ISSUE: Permit to Demolish/Capsulate (partial) and Certificate of Appropriateness for alterations

APPLICANT: Deven McGraw and David Parker

LOCATION: Old and Historic Alexandria District
115 Quay Street

STAFF RECOMMENDATION

Figure 1. Existing front (south) and side (east) elevations.

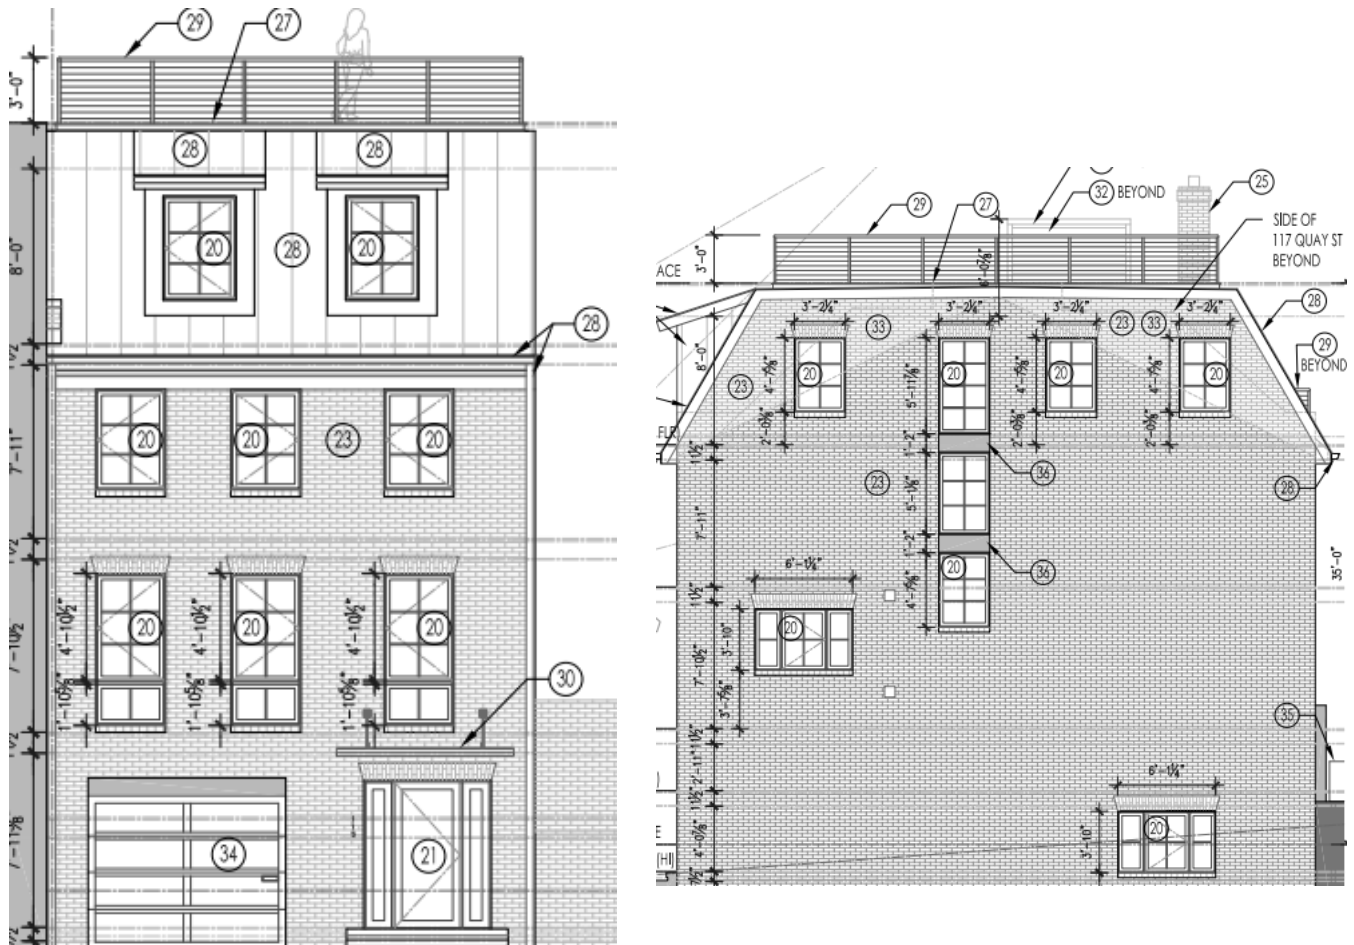
However, staff does have some concerns about the alignment of the windows. On the south (front) elevation, the three window bays do not align with the two dormer windows, and on the east (side) elevation, the windows do not align horizontally. The Board had concerns about the symmetry of the window alignment on another recent case nearby, at 114 Princess Street (BAR2024-00404). In that case, the Board approved the addition of several windows on the side elevation but required the applicant to work with staff on the alignment to make it more symmetrical. Staff is happy to work with the applicant of the subject property in a similar way.

Therefore, staff recommends approval of the Certificate of Appropriateness for alterations, with the following conditions:

1. Work with staff to modify the alignment of the windows on the south and east elevations to be more symmetrical.
2. Awning hardware should be installed into the mortar joints to avoid damage to the brick.
